Preliminary Consultation
MONTGOMERY COUNTY HISTORIC PRESERVATION COMMISSION
STAFF REPORT

Address:	5605 York Ln., Bethesda	Meeting Date:	10/9/2019
Resource:	Contributing Resource (Greenwich Forest Historic District)	Report Date:	10/2/2019
Applicant:	Kathryn Becker Revocable Trust (David Schindel, Architect)	Public Notice:	9/25/2019
Review:	Preliminary Consultation	Tax Credit:	N/A
Case Number:	N/A	Staff:	Michael Kyne
PROPOSAL:	Porch construction

Proposed Site Plan

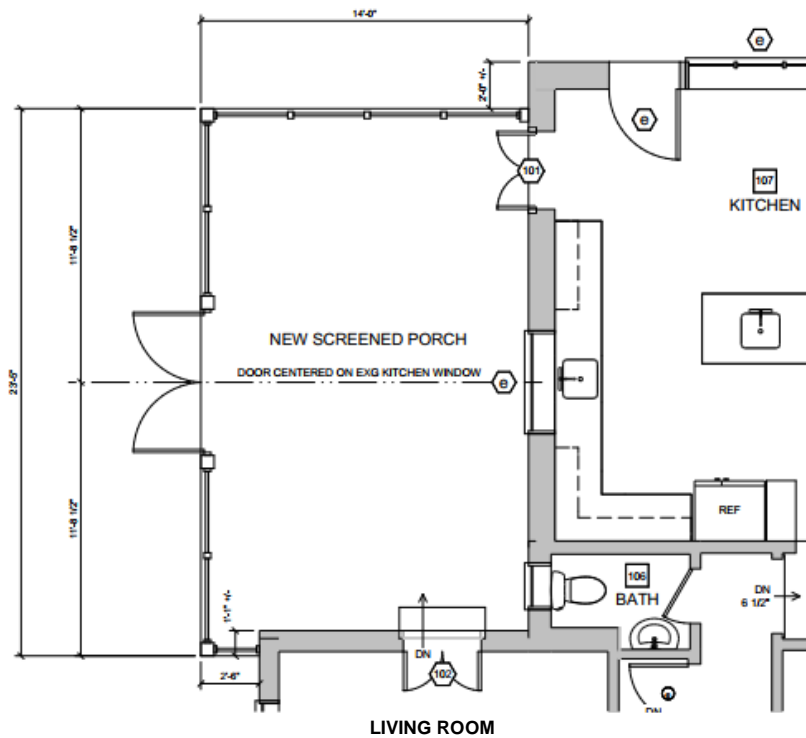
- *D5. Guidelines on dimensions:*
 - The proposed three-season porch will increase the total lot coverage of the subject property house to 11.9%, which is well below the allowable 25%. The side setback between the proposed three-season porch and the neighboring house to the north-west is in excess of the stipulated 18', with more than 7' on each side. Additionally, as measured

from its rear elevation, the proposed three-season porch is in excess of 25' from the rear lot line.

Northwest elevation

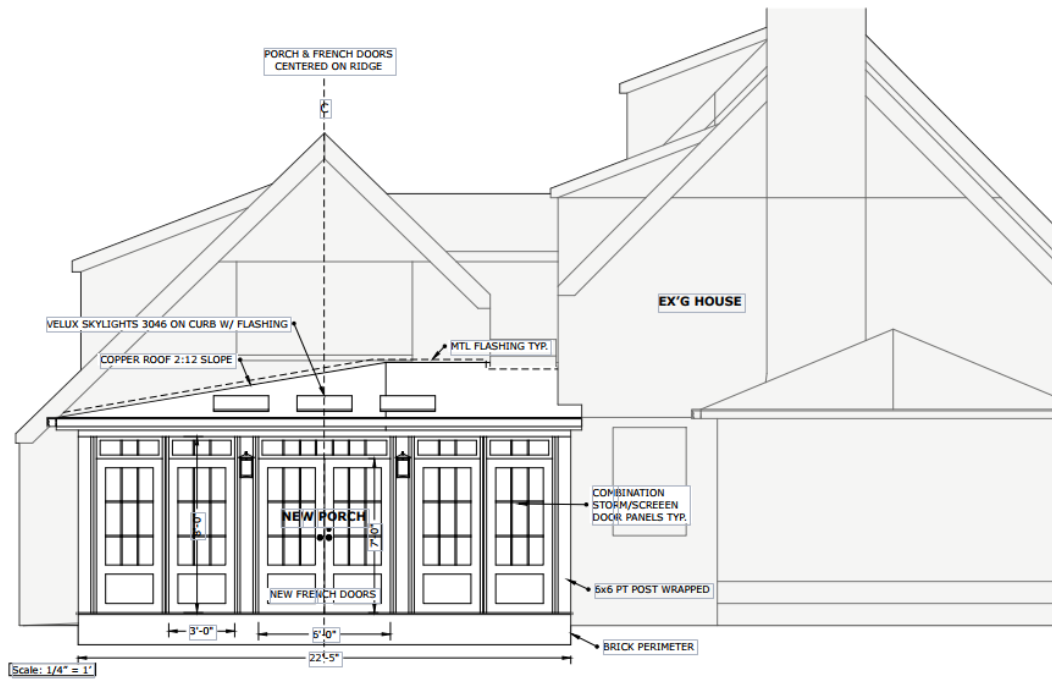
- *D4. Additions:*
 - The proposed three-season porch is compatible with the style of the historic house, located at the rear of the historic house, and, although it will project 2'-6" beyond the north-west (left) side of the historic house, it will preserve a recognizable outline of the historic house.

- The Commission typically requires additions to be inset from the rear corners of the historic house. This is consistent with the purpose of the *Guidelines*, which stipulate that additions must preserve a recognizable outline of the historic house. As noted above, although the proposed three-season porch will project 2'-6" beyond the north-west (left) side of the historic house, staff finds that it will preserve a recognizable outline of the historic house. Additionally, staff finds that the proposal will not remove or alter character-defining features of the historic house, in accordance with *Standards #2* and *#9*. In accordance with *Standard #10*, the proposed three-season porch will be constructed in a manner that, if removed in the future, the essential form and integrity of the historic property and its environment would be unimpaired.

Staff notes that the view of the proposed three-season porch will be obscured from the front by the existing enclosed porch/study at the north-west side of the historic house.

Northeast elevation

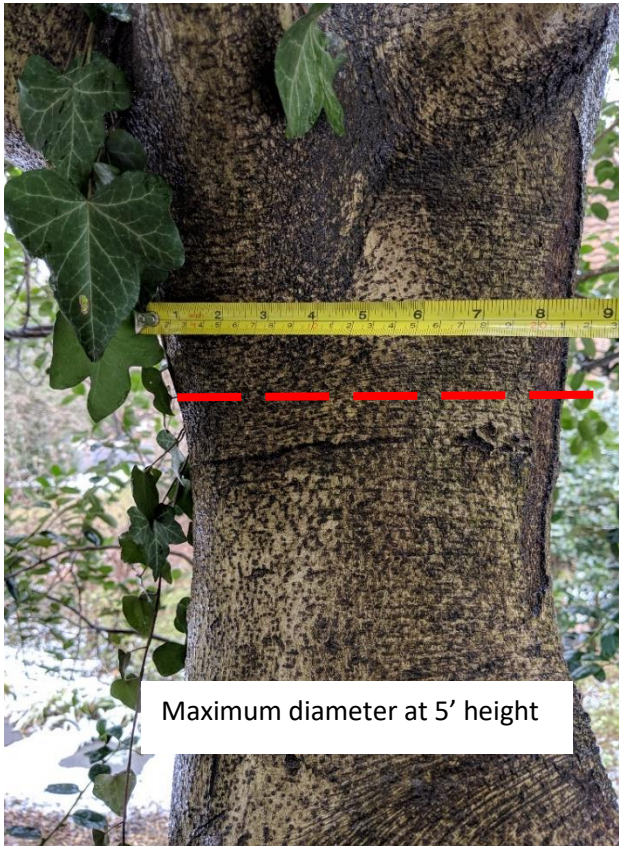
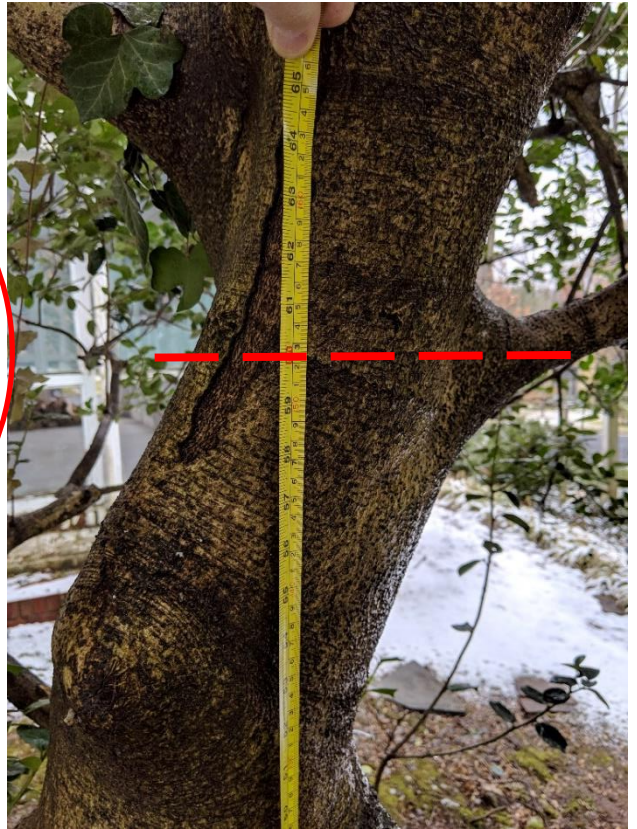
- Staff asks for the Commission's guidance regarding the appropriateness of the proposed materials, specifically the synthetic PVC-wrapped framing and the proposed screens and storm panels, for which specifications have not yet been provided. As noted above, staff recommends that the proposal be reviewed with moderate scrutiny, which states "[u]se of compatible new materials or materials that replicate the original, rather than original building materials, should be permitted." Staff finds the proposed materials consistent with the *Guidelines* and with *Standards #2* and *#9*.
